STAFF REPORT

CITY OF COLUMBUS PLAN COMMISSION (June 10, 2026 Meeting)

Docket No. / Project Title: SDP-26-22 (Cummins Parking Garage)
Staff: Desiree Aldrich

Applicant: Cummins
Property Size: 1.45 Acres
Current Zoning: CD (Commercial: Downtown)
Location: 601 Jackson Street, in the City of Columbus

SITE PLAN

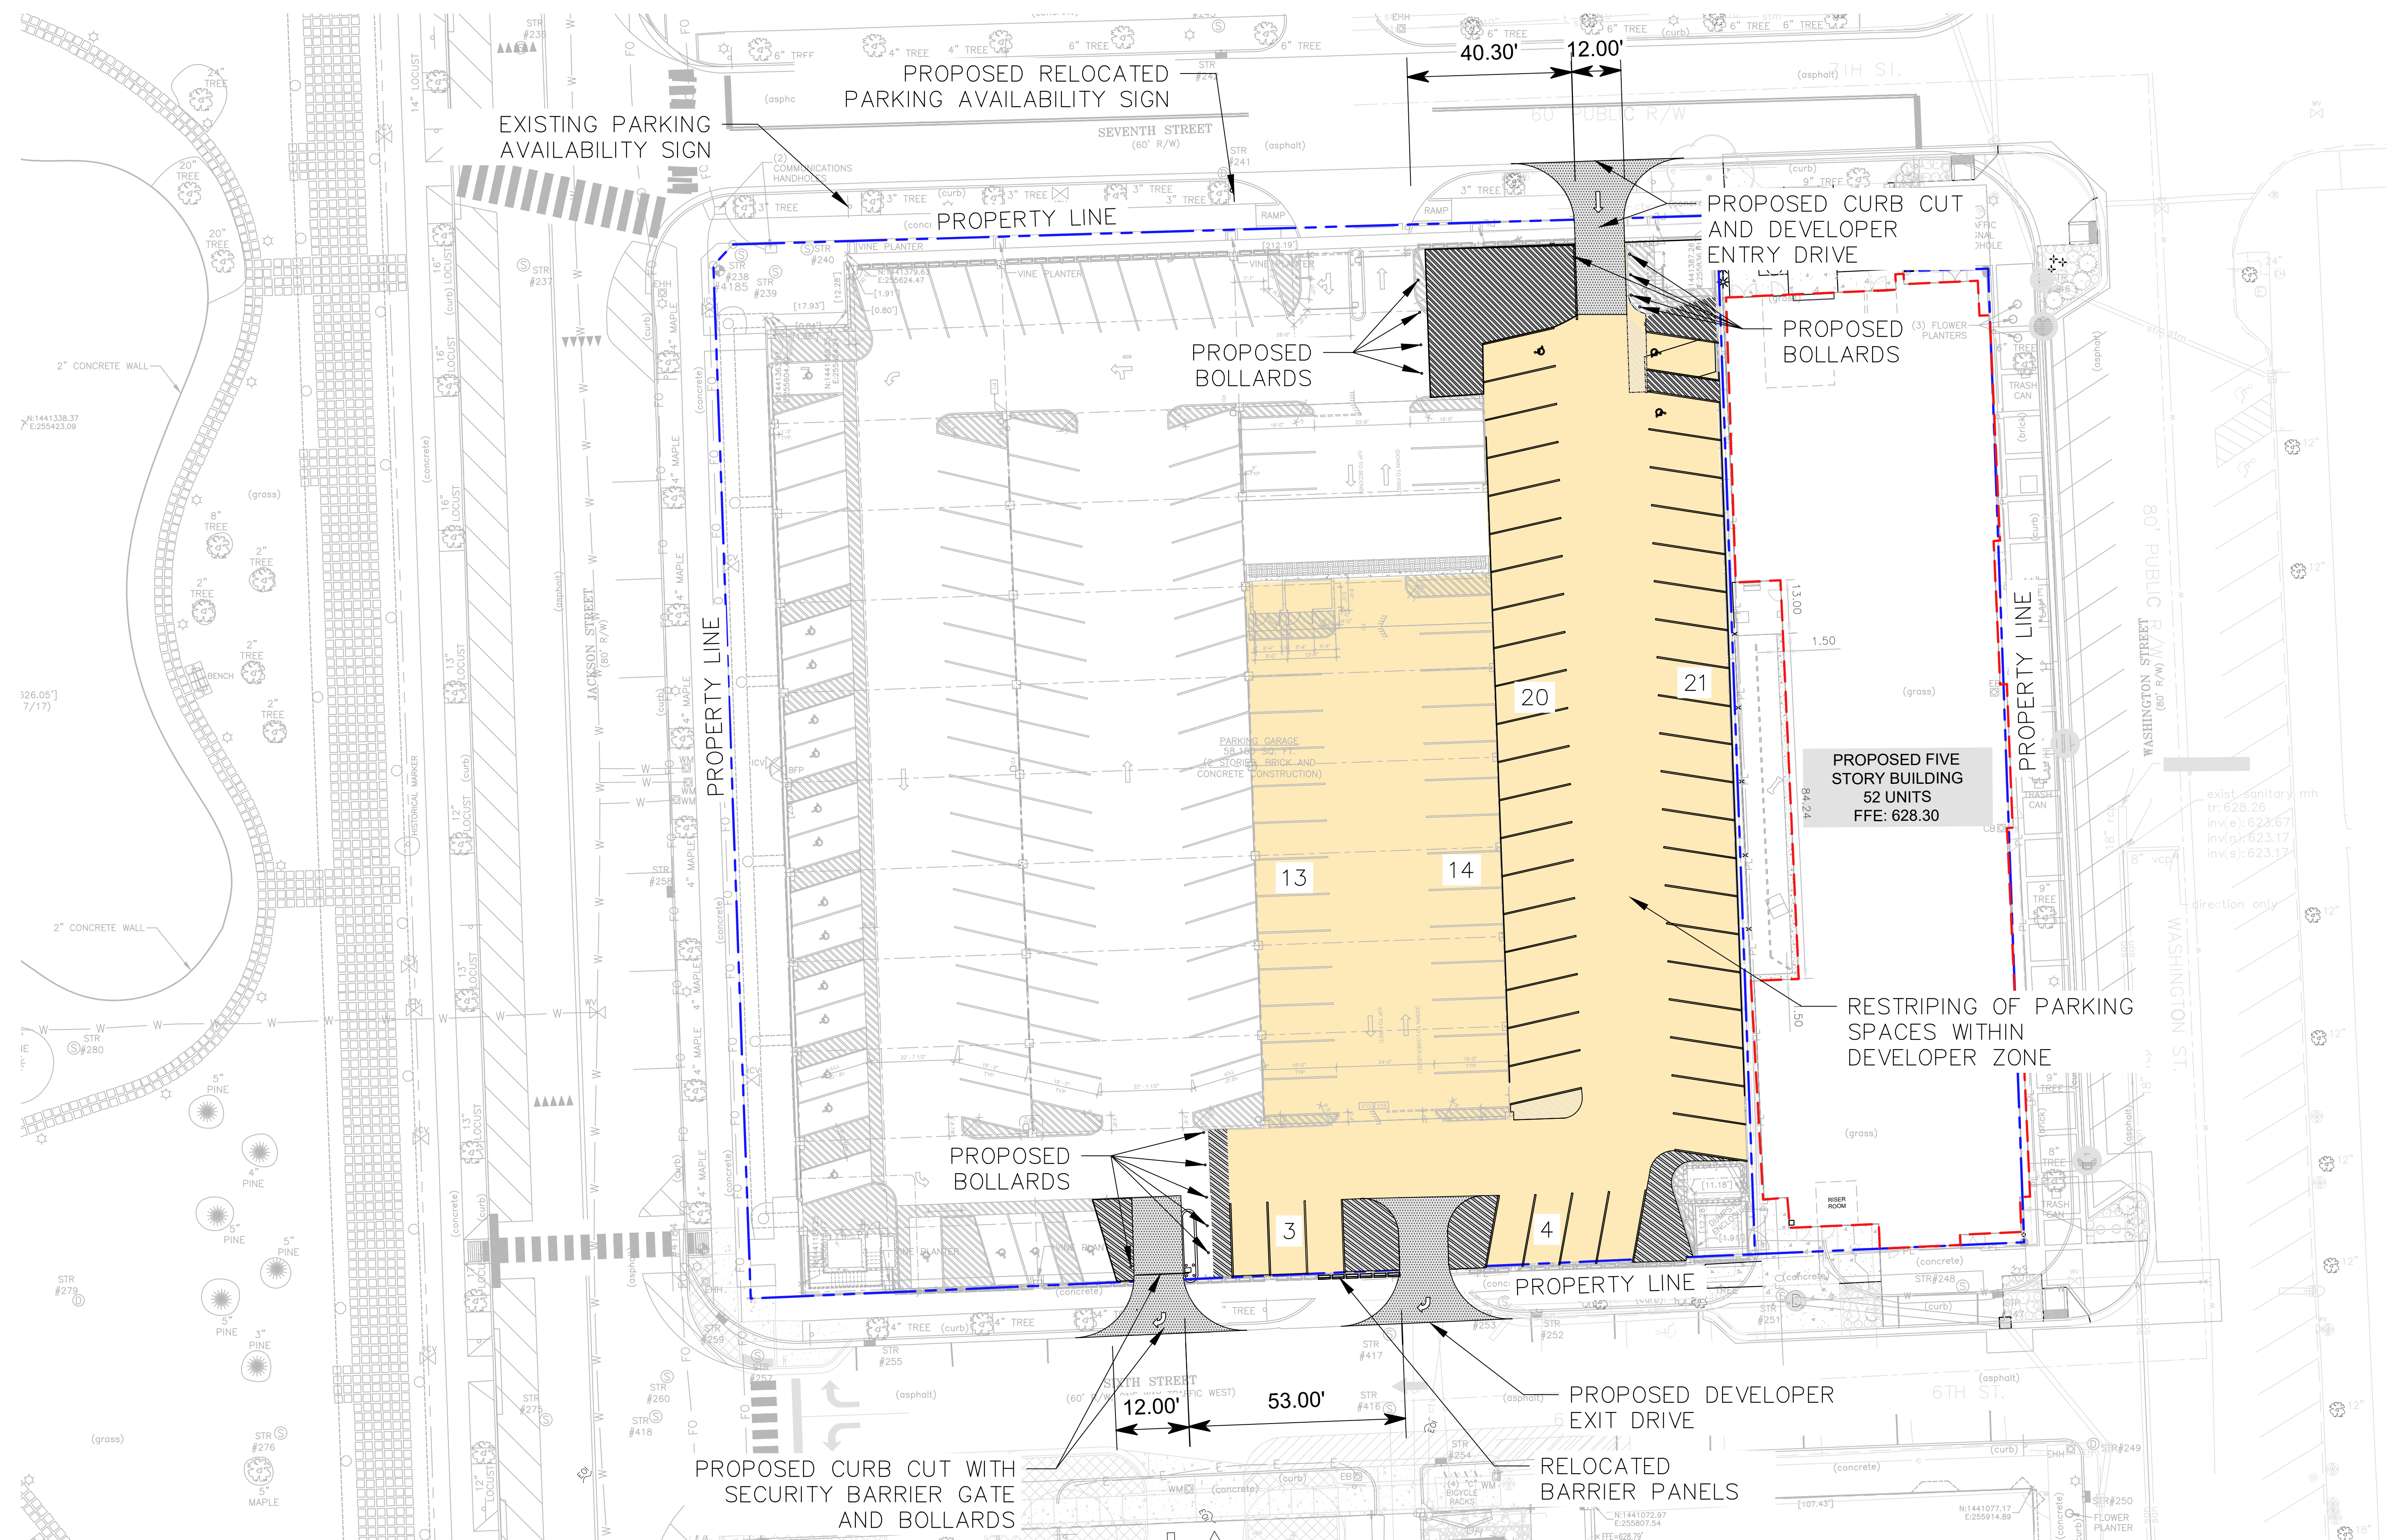
1. The drawings provided shall be labeled as the "Cummins Parking Garage Site Development Plan Major Modification".
2. Separation distances for the new drives shall be shown from the nearest adjacent drive and/or street intersection in each direction and measured from the centerlines of the drives and intersections as specified by Zoning Ordinance Section 7.3(Part 1)(C)(3).
3. The dimensions for all re-stripped spaces shall be provided and all shall comply with the requirements of Zoning Ordinance Section 7.2(Part 1)(A)(3) and Table 7.6.
4. The proposed new drives shall be widened from 12-feet to 14-feet to comply with Zoning Ordinance Section 7.2(Part 4)(B)(4)(a).
5. Where the proposed new exit drive is to be installed along 6th Street, the resulting excess existing driveway pavement in the right-of-way shall be removed, and a curb and tree lawn will be established.

Interdepartmental Review:	
City Engineering:	The Engineering Department has concerns with drive separation, distance to the nearby intersections, and removing on-street parking as proposed.
City Utilities:	No concerns.
Fire Department:	No comments received.
Bartholomew County Code Enforcement:	No comments received.

- a. Arterial Street or Road: 400 feet.
 - b. Collector Street or Road: 200 feet.
 - c. Local Street or Road: 100 feet.
8. The proposed separation distances from the new access points are approximately 65 feet from the proposed driveways off 6th Street and 52 feet from the proposed driveways off 7th Street.
